Work Order ID 72589

Item Name: Basket Hoop

DESIGN #	DRAWN BY CP	DART AEROSPACE LTD HAWKESBURY, ONTARIO, CANADA	
CHECKED #	APPROVED #	DRAWING NO. D3166	REV. A SHEET 1 OF 1
DATE 02.07.10		TITLE BASKET HOOP	SCALE NTS
A	02.07.10	NEW ISSUE	
A1	04.04.08	38+/-1 WAS 36.0

DRAWING NO. D3166	TITLE BASKET HOOP	REV A1	DART AEROSPACE LTD ENGINEERING ORDER		D.E.O. NO. D3166-A-2	SHEET NO. 1 OF 1	SCALE NTS
DRAWN AJS	CHECKED L	MFG. APPR. M	APPROVED M		DE APPR. H		
DATE 08.12.11	DATE 08.12.15	DATE 08/12/15	DATE 08/12/16		DATE 08.12.16

D3166-1 BASKET HOOP

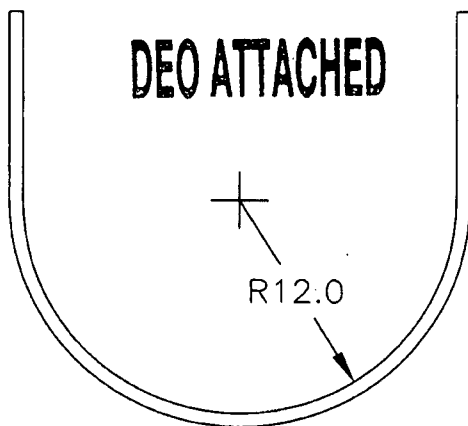
1) MODIFY MATERIAL NOTE FOR D3166-1 AS SHOWN:

WAS:

- 1) MATERIAL: AISI 304/316 SS SQUARE TUBING,
0.75" x 0.75" x 0.063 WALL, 60.00" LONG
(REF DART SPEC. M304TS0.750W.063)

IS:

- 1) MATERIAL: AISI 304/316 SS, 3/4 X 3/4 X 0.065 WALL SQUARE TUBING,
60.00" LONG
REF. DART SPEC M304TS0.750W.065

D3166-3 BASKET HOOP

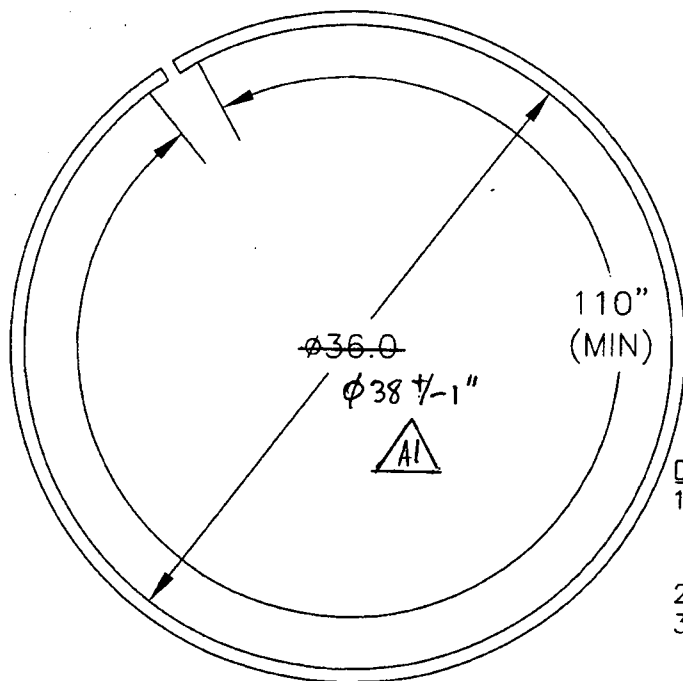
2) MODIFY MATERIAL NOTE FOR D3166-3 AS SHOWN:

WAS:

- 1) MATERIAL: AISI 304/316 SS SQUARE TUBING,
0.75" x 0.75" x 0.063 WALL, 120.00" LONG
(REF DART SPEC. M304TS0.750W.063)

IS:

- 1) MATERIAL: AISI 304/316 SS, 3/4 X 3/4 X 0.065 WALL SQUARE TUBING,
120.00" LONG
REF. DART SPEC M304TS0.750W.065
